HARTZELL PROPELLER INC.
SERVICE BULLETIN
HC-SB-61-373

**Propeller - Propeller Mounting Nut Torque Inspection
and Replacement**

Propeller Mounting Studs/A-2044 Mounting Nuts
Figure 1

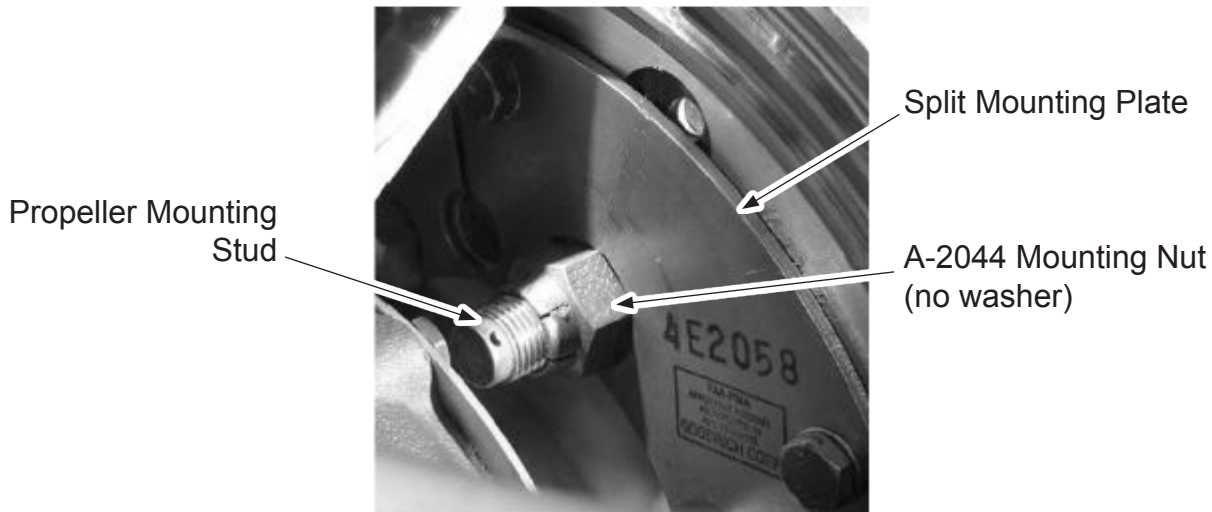
- (1) Textron Aviation has informed Hartzell Propeller Inc. that the affected propellers were installed with A-1381 washers under the A-2044 propeller mounting nuts.
 - (a) All of the affected propellers are equipped with a de-ice system that requires a split mounting plate for installation onto the engine flange. The A-1381 washers do not fit correctly against the split mounting plate and can deform when the A-2044 mounting nuts are torqued.
 - 1 Deformed A-1381 washers can cause the A-2044 mounting nuts to lose the required torque.
 - a If the A-2044 mounting nuts lose the required torque, the propeller can become loose on the engine flange and cause damage to the mounting studs and/or the hub.

- (2) Remove the spinner dome in accordance with Hartzell Propeller Inc. Owner's Manual 115N (61-00-15).
- (3) Visually examine the propeller mounting studs and A-2044 mounting nuts. Refer to Figure 1.

- (a) If there are washers installed under the A-2044 mounting nuts, go to step 3.A.(4).
 - (b) If there are no washers installed under the A-2044 mounting nuts, no further action is required.

- 1 Remove and discard all six A-2044 mounting nuts and A-1381 washers.
 - 2 Install six new A-2044 mounting nuts in the correct sequence in accordance with Hartzell Propeller Inc. Owner's Manual 115N (61-00-15).

- a The installation torque for the A-2044 mounting nuts is 70-80 Ft-Lbs (95-108 N•m) dry.
- (6) Make a record in the propeller logbook indicating compliance with the propeller mounting nut torque inspection as terminating action for Hartzell Propeller Inc. Service Bulletin HC-SB-61-373.
